SOUTHWEST BIKEPATH CULVERT REPLACEMENT AT WAITE CIRCLE - 2019

CITY OF MADISON, WI

CITY PROJECT NO. 8466

ADDENDUM 1
8/29/19
CHANGED ENTIRE
DRAWING

**CIVIL
PROPOSED PLAN &
PROFILE - BOX
CULVERT**

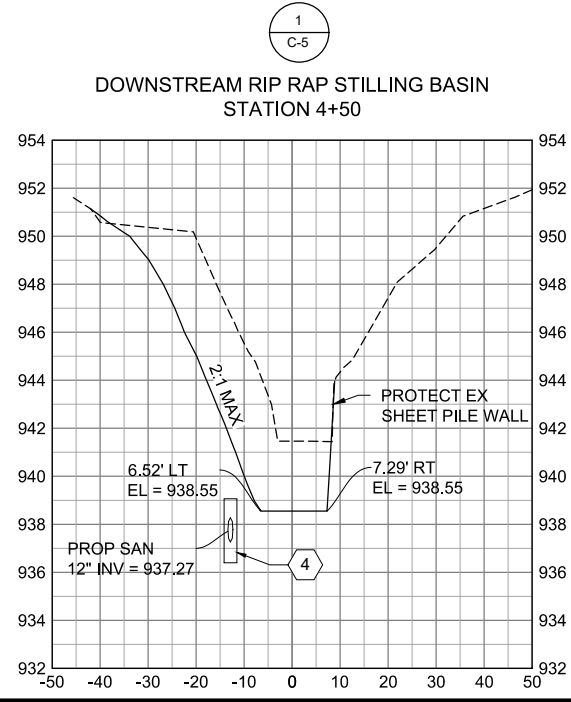
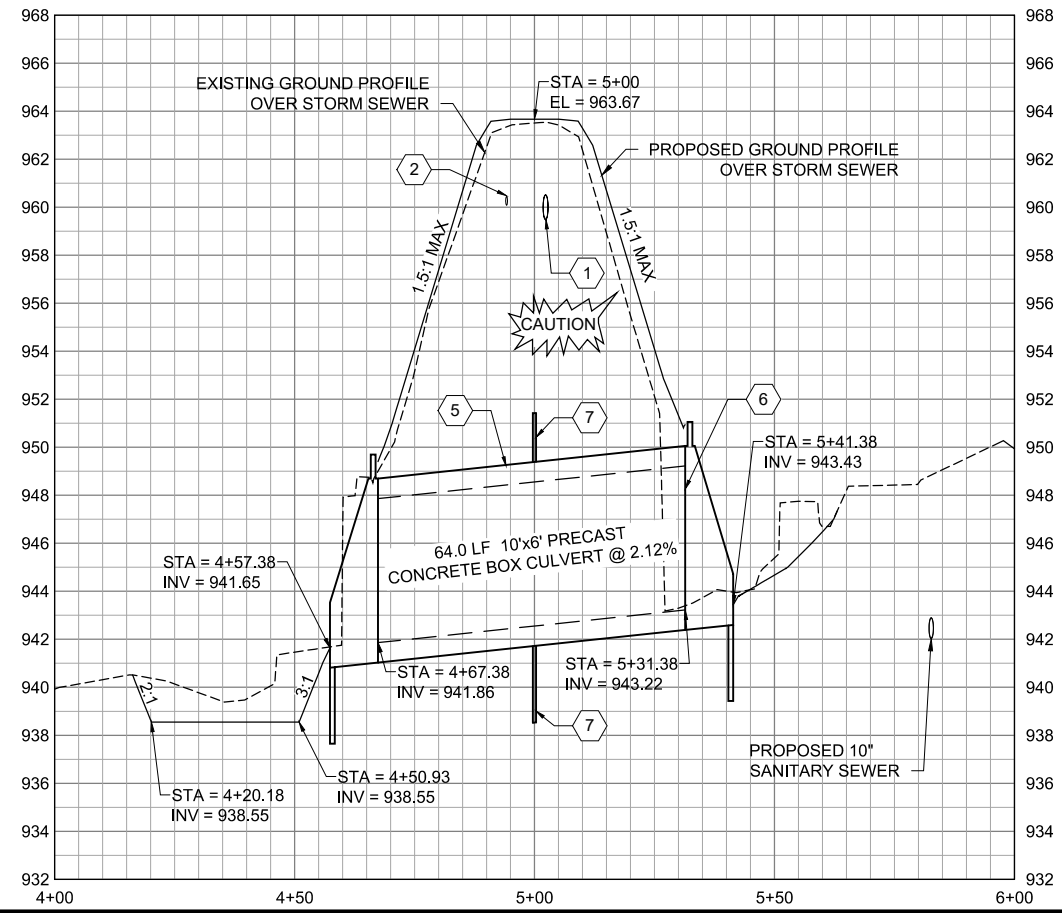
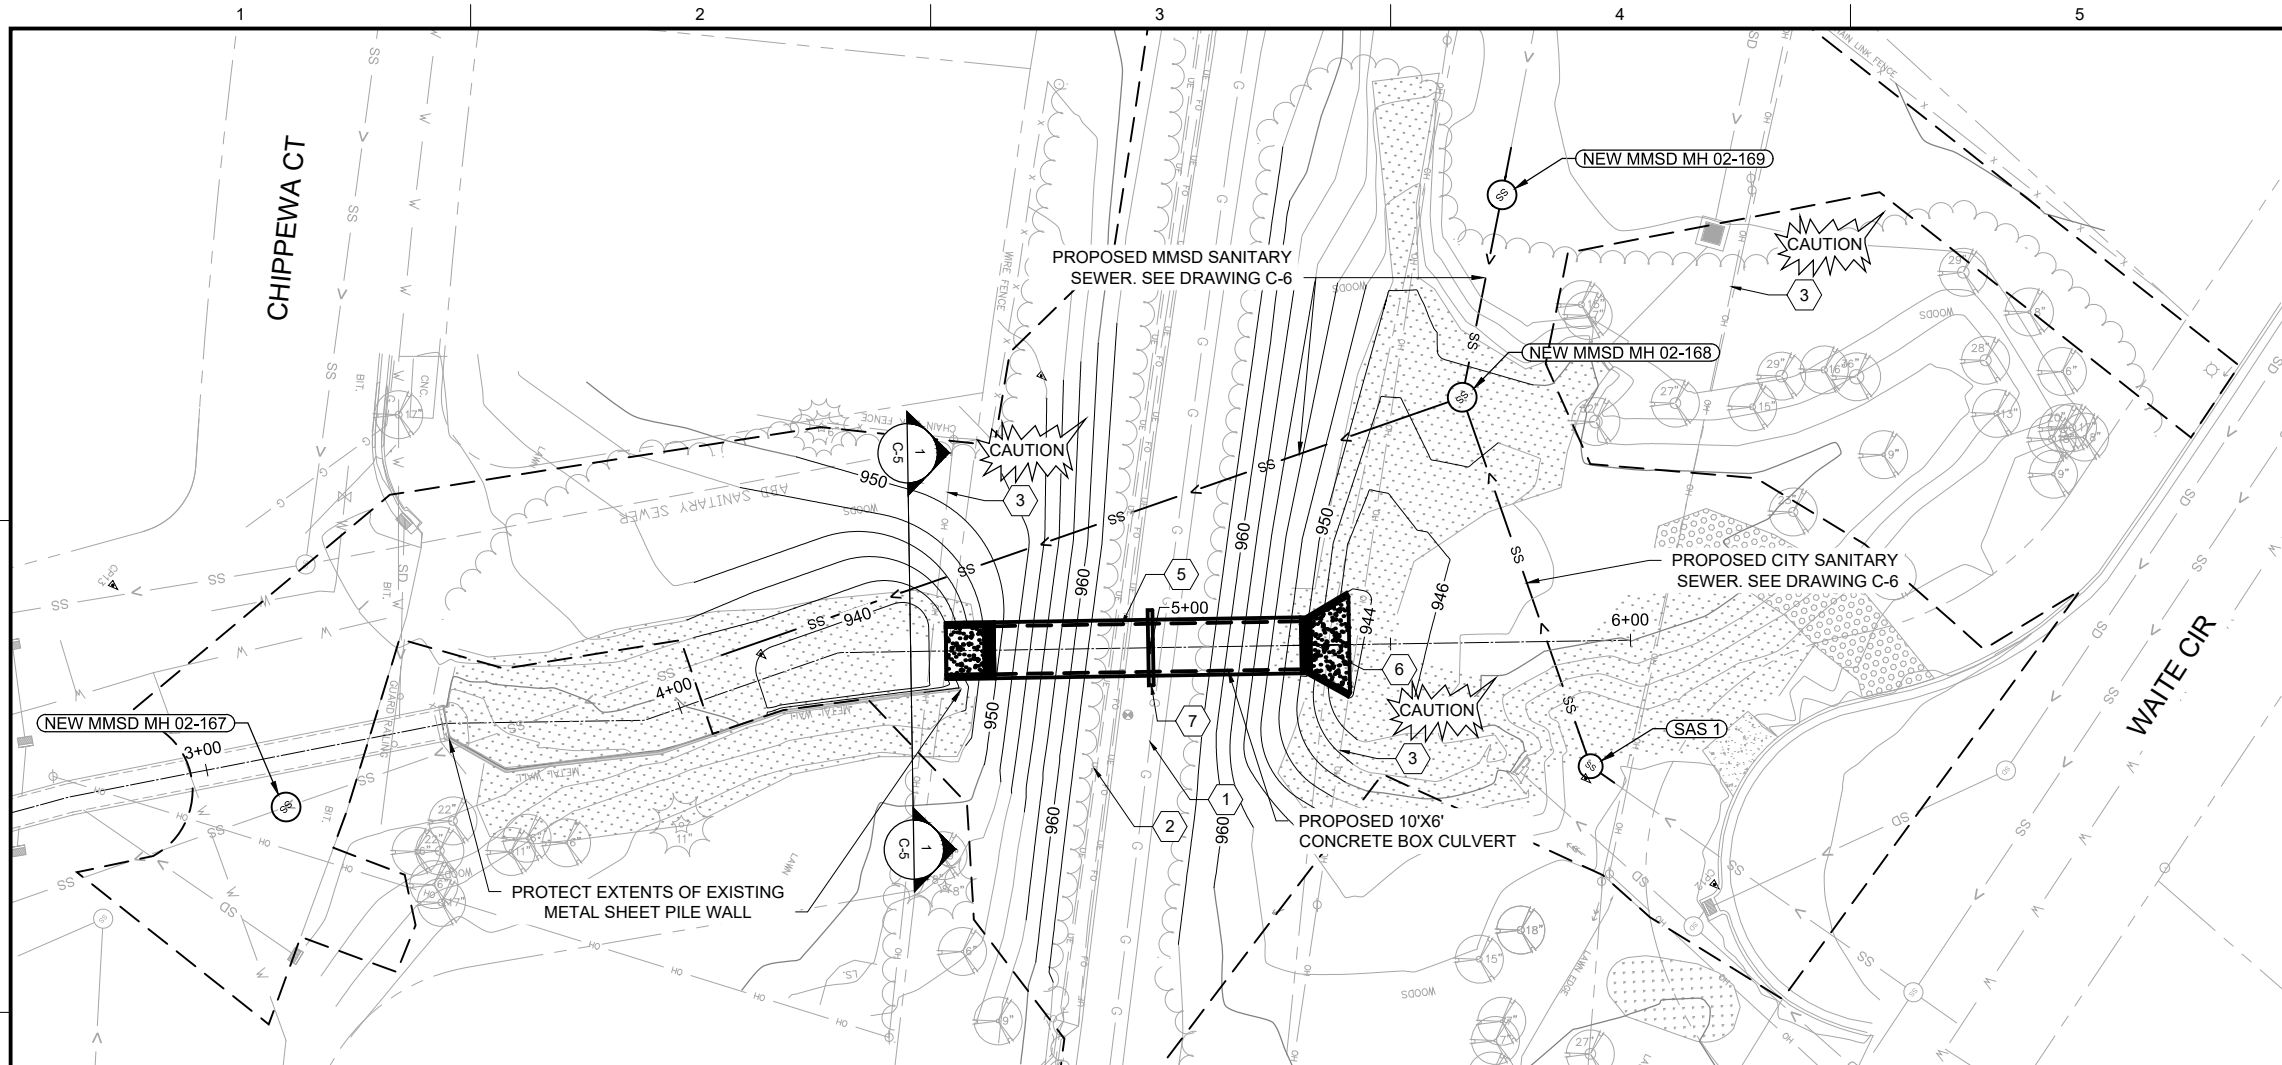
**ADDENDUM 1
CHANGED
ENTIRE
DRAWING**

**PROPOSED PLAN &
PROFILE -
SANITARY SEWER**

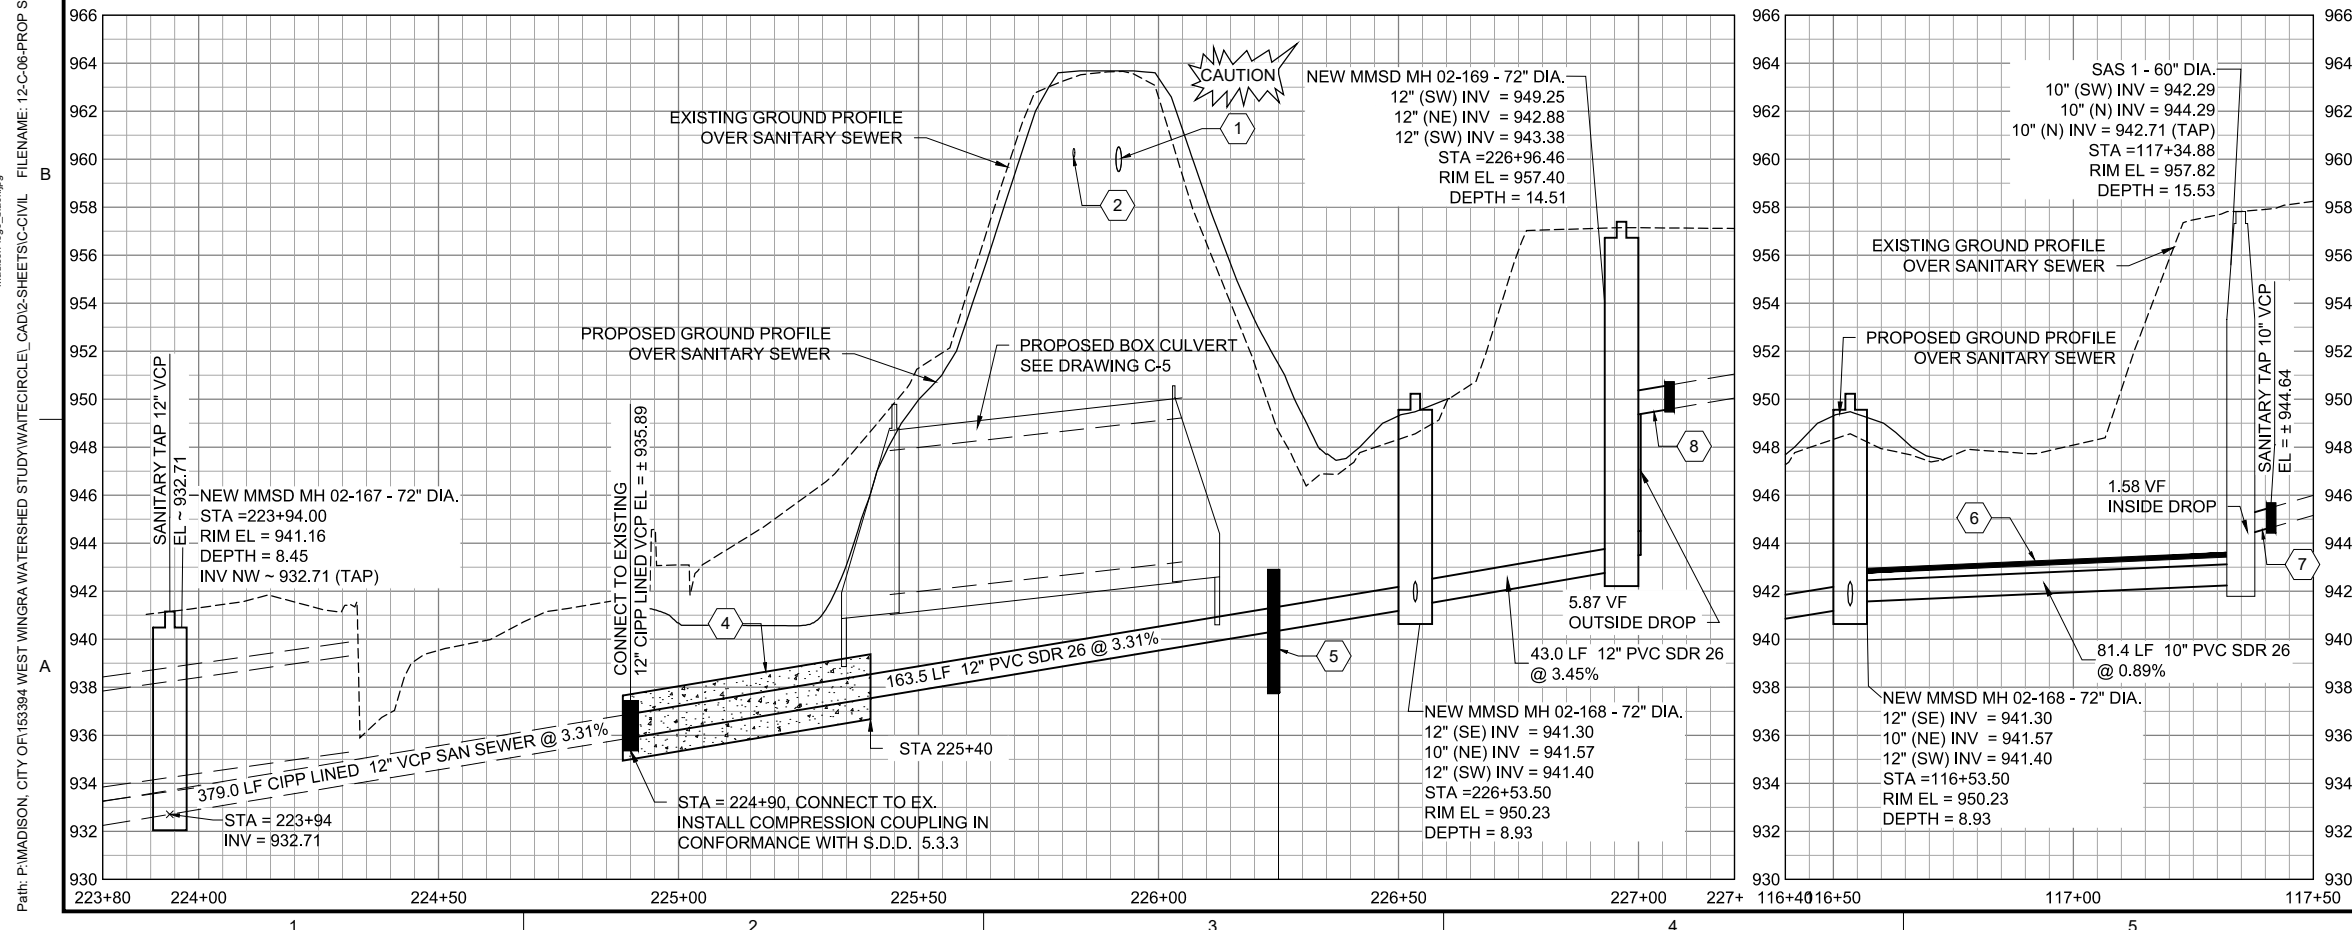
**ADDENDUM 1
CHANGED
ENTIRE
DRAWING**

**CIVIL
PROPOSED PLAN &
PROFILE - BIKE
PATH**

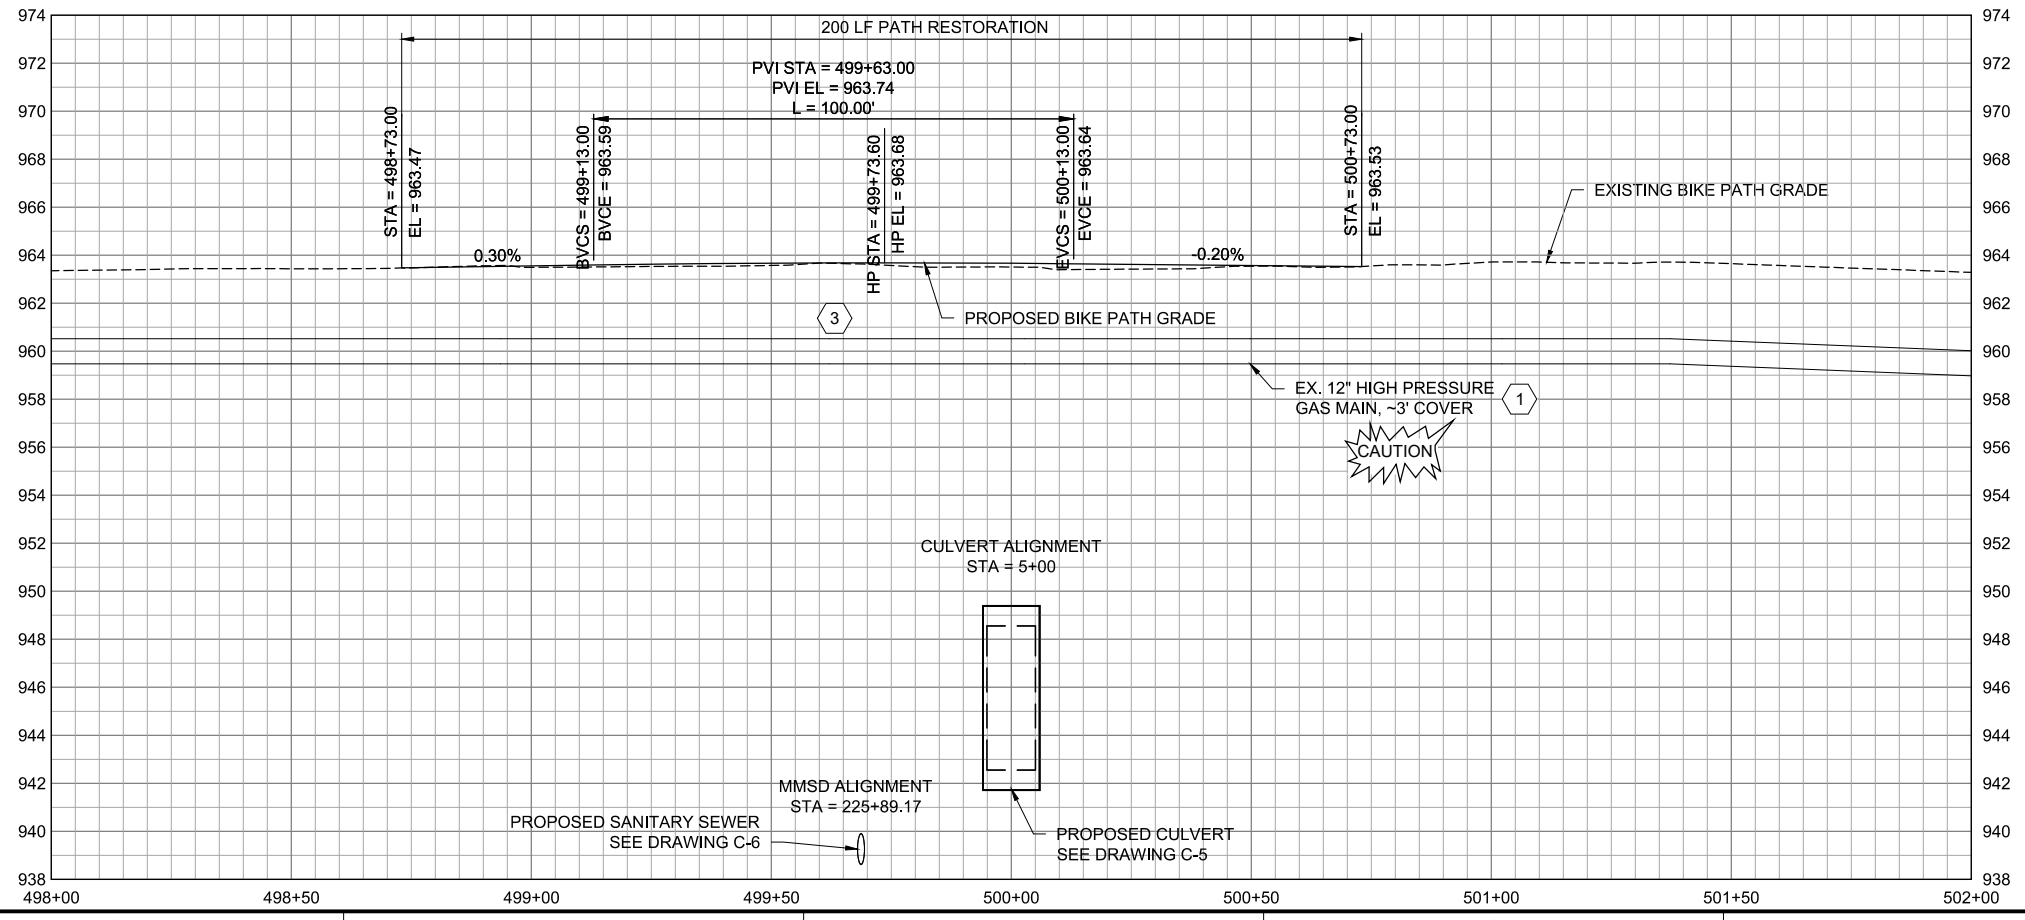
**ADDENDUM 1
CHANGED
ENTIRE
DRAWING**

CIVIL
PROPOSED GRADING & RESTORATION PLAN

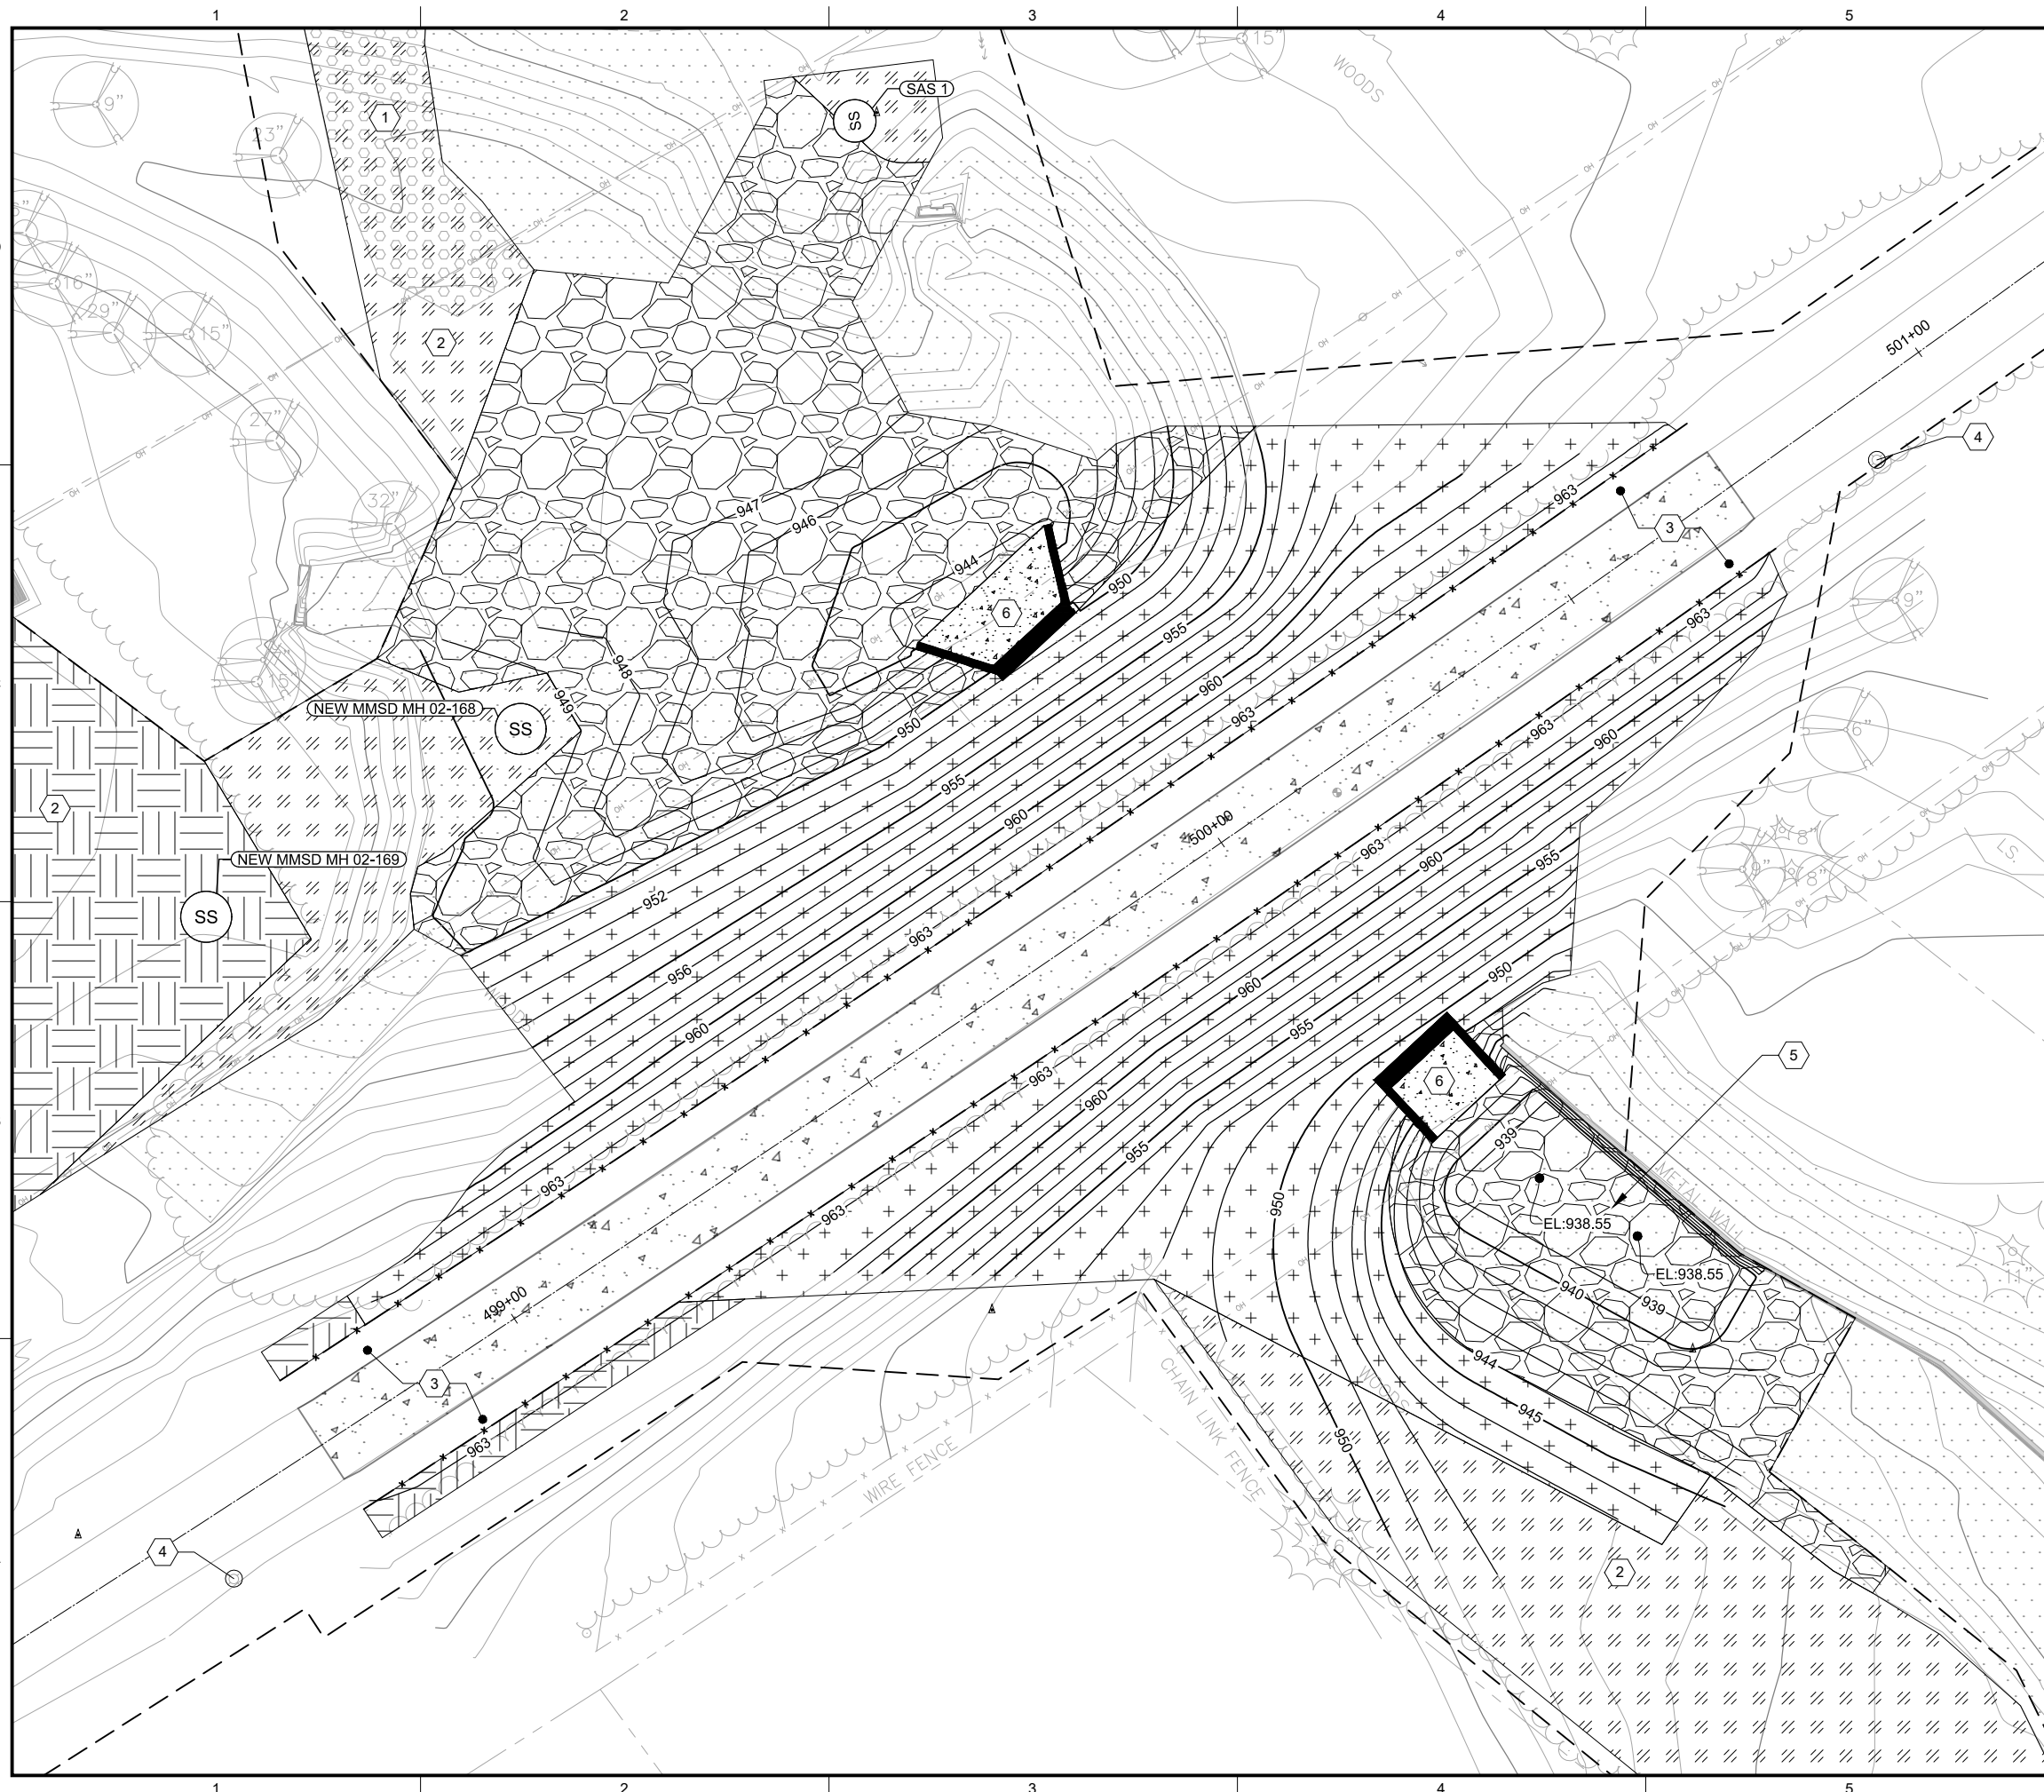
ADDENDUM 1 CHANGED ENTIRE DRAWING
